MIL-B-5087B(ASG)  
Amendment 2  
31 August 1970  
Superseding  
Amendment 1  
6 February 1968

MILITARY SPECIFICATION

BONDING, ELECTRICAL, AND LIGHTNING PROTECTION, FOR AEROSPACE SYSTEMS

This amendment forms a part of Military Specification MIL-B-5087B(ASG), 15 October 1964, and has been approved by the Department of the Air Force and by the Naval Air Systems Command.

FIGURE 6. Fault current (Amperes)

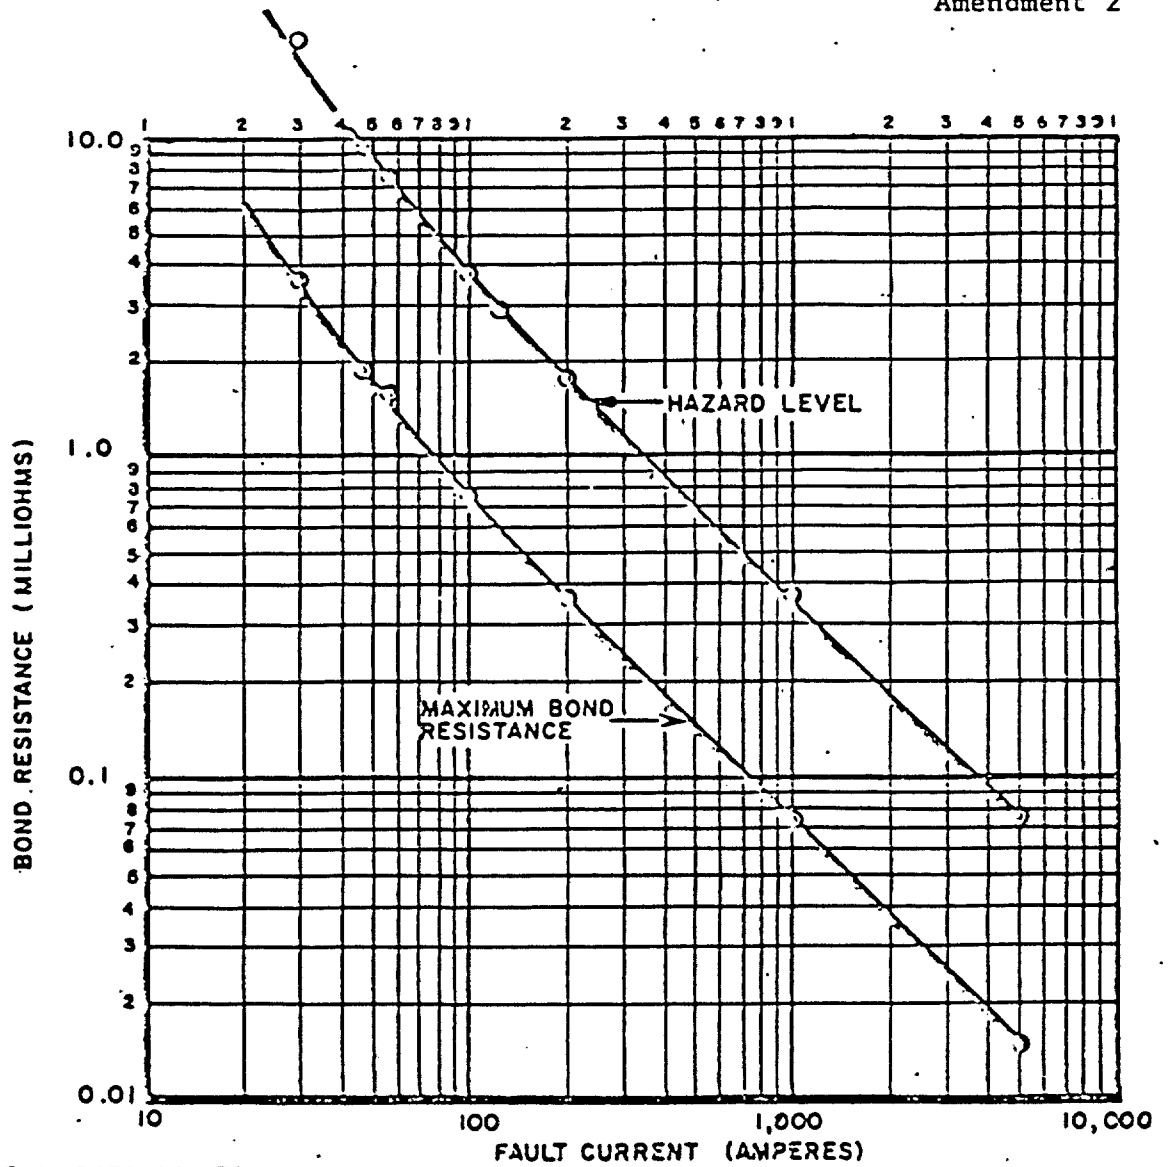
"3.3.2.4 Bonding in hazard areas. In areas prone to explosion or fire hazards; the resistance between the equipment case and structure shall not exceed the values shown on figure 6. The fault current shown is the maximum current that the electrical system is capable of delivering to the fault in the event that an internal power-to-ground fault takes place and high current passes through the equipment housing to structure. Since bonding in itself cannot eliminate all possible sources of ignition, the equipment shall be designed to minimize hot spots, sparking, and expulsion of molten metal when an internal power fault occurs.

Page 13, figure 6: Delete and substitute the attached figure 6. Figure 6 forms page 3 of this amendment.

NOTE 1. DATA POINTS

AMPS	HAZARD RESISTANCE (MILLIOHMS)	MAX RESISTANCE (MILLIOHMS)
5000	0.074	0.0143
1000	0.37	0.074
200	1.35	0.37
120	2.33	—
100	3.7	0.74
58	7.7	1.54
49	9.3	1.35
30	18	3.6
